SERVICE-INFO

Assembly instructions for tensioner 534 0412 10

Manufacturer: Ford
Model: Galaxy, Mondeo IV, S-Max
Engine: 1.8 TDCi
OE numbers: 6G9Q-6A228-BC / 1425510
8G9Q-6A228-AA / 1567809
Part no.: 534 0412 10

Image 3: bolts

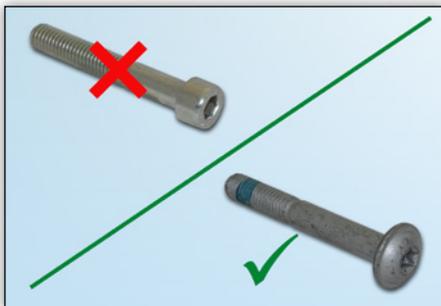
When installing the tensioner 534 0412 10 offered by Schaeffler Automotive Aftermarket, it is imperative to ensure that the bolt removed from the old tensioner is replaced with the new bolt enclosed (**Image 3**).

You must use the new bolt enclosed with the tensioner!
